**Request for Bids
Construction of New Single Family Home
Bid No.: B16-029
Issue Date: June 20, 2016**

Addendum No. 1

Project: 108 3rd Street Home

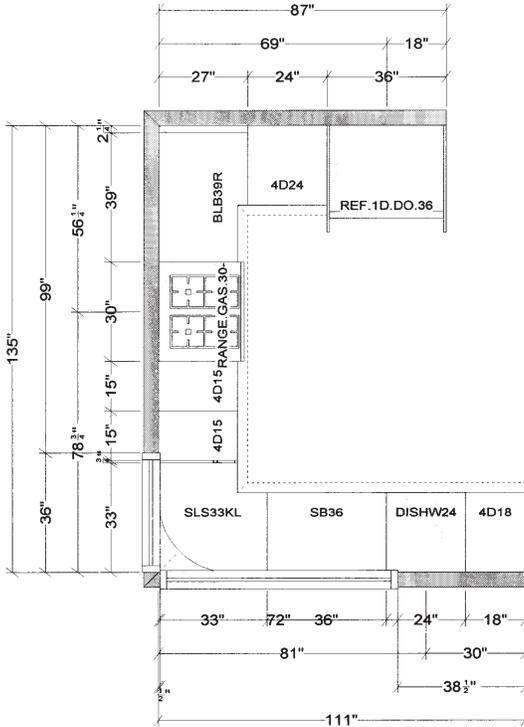
Question 33: Will a corner cabinet be required in the Kitchen? It is missing.

Please refer to the diagram below as a possible general scenario for cabinet layout
